## WHALE BEACH NEIGHBOURHOOD CENTRE 231 WHALE BEACH RD WHALE BEACH

# STORMWATER ASSET RELOCATION INVESTIGATION & REPORT Job No 190210

COUNCIL COMMENTS RE CONCEPTUAL DESIGN

WHALE BEACH ROAD STORMWATER
INFRASTRUCTURE WORKS
(plans by Barrenjoey
Consulting Engineers pty ltd)

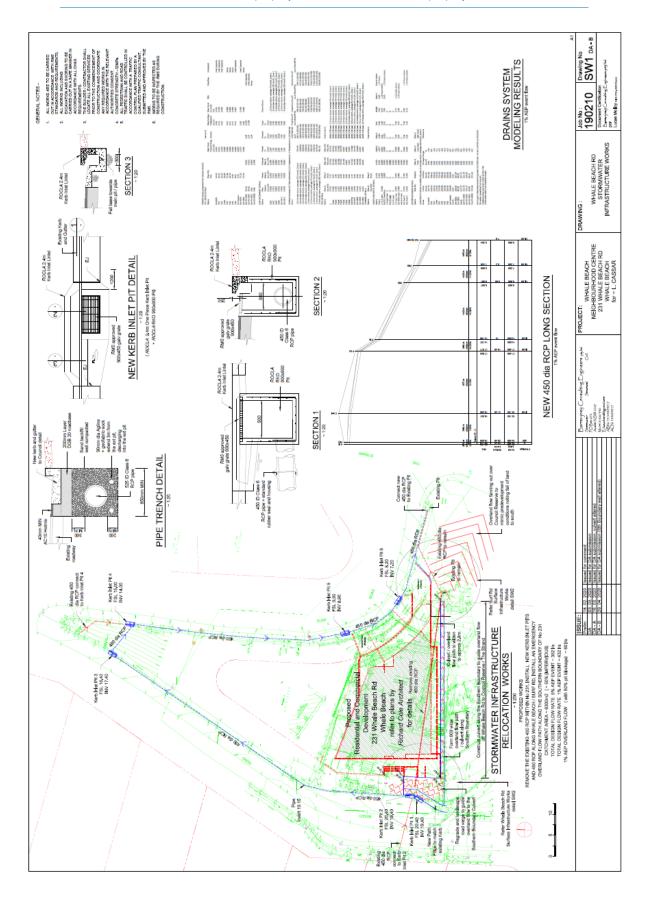
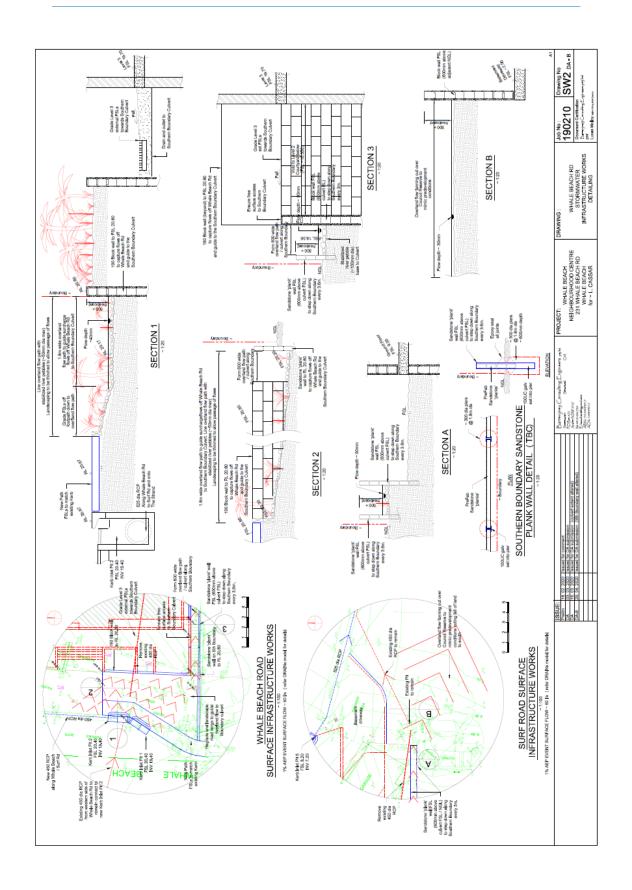
- 1. The proposal is to divert Council's existing stormwater 450mm pipe along the Whale Beach Road and Surf Roads in the report prepared by Lucas Molloy of Barrenjoey Consulting Engineers pty Itd, is supported in principal. All associated costs with the relocation of Councils drainage system, any utility services adjustments reinstatement are to be borne by the owner.

- 2. Council pipe line shall be located below the kerb and gutter.
- 3. The pipe cover and grades must comply with the manufacturer's specifications.
- 4. All existing drainage system in Surf Road are to be connected into the proposed drainage system.

- 5. The proposed culvert under the driveway (South-west corner) with a grating is not supported due to blockage, maintenance issues and overflow considerations. An unobstructed overland flow path for the 100 year ARI flows must be provided.
